# UNITED STATES PATENT AND TRADEMARK OFFICE

APPLICATION NO.	FILING DATE	FIRST NAMED INVENTOR	ATTORNEY DOCKET NO.	CONFIRMATION NO.
10/618,272	07/11/2003	Chun He	2107-26	4842
26797	7590	06/15/2005	EXAMINER	
SILICON VALLEY PATENT AGENCY 7394 WILDFLOWER WAY CUPERTINO, CA 95014			MACK, RICKY LEVERN	
			ART UNIT	PAPER NUMBER
			2873

## DETAILED ACTION

Fig.3

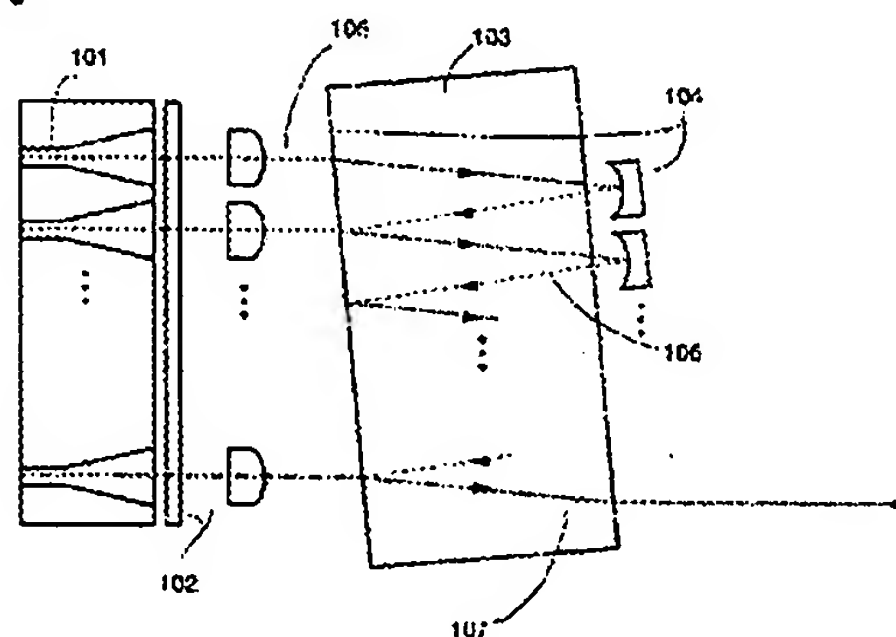
Neuberger discloses, as in claims 1 and 13, a module comprising: at least a concave mirror (104) placed in such way that an incident traveling distance of a light beam to the concave mirror is equal or substantially similar to a reflective traveling distance of the light beam from the concave mirror (see figure 3 below). Though Neuberger does not explicitly disclose the tilting error correction, this feature is considered an inherent function of the device employing the concave reflector in the multiplexing device disclosed.

multiplexing device disclosed, and the angular error and a later shift error of claim 8, absent additional structure, is likewise considered inherent to Neuberger (see fig. 3, col. 5, lines 50-52).
